Technical Service Bulletin

SUBJECT: Functional issue with emergency stop button (Design B). When pressed, the button may not remain engaged in the lock-out position as designed. In this condition, the switch will still disable machine when pressed, but the button must be held for one to two seconds on some models such as the T5, T7 and R14.

Emergency Stop Button (Design B)

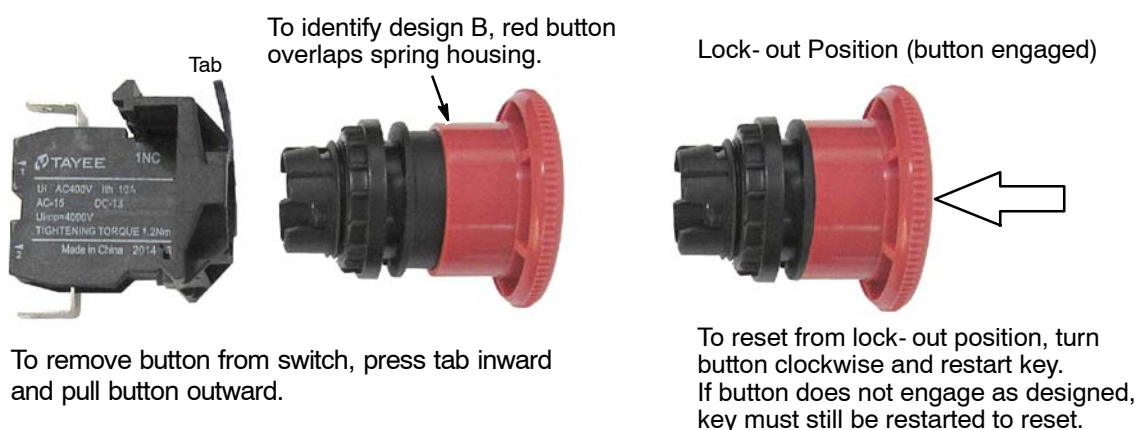
PURPOSE: For machines equipped with emergency stop button (Design B), it's recommended to replace with emergency stop button (Design A) p/n 1011735.

Replace with Emergency Stop Button, p/n 1011735 (Design A)

Note: Both emergency stop button designs share the same part number, confirm correct design before installing. Emergency stop button (Design B) has been removed from inventory.
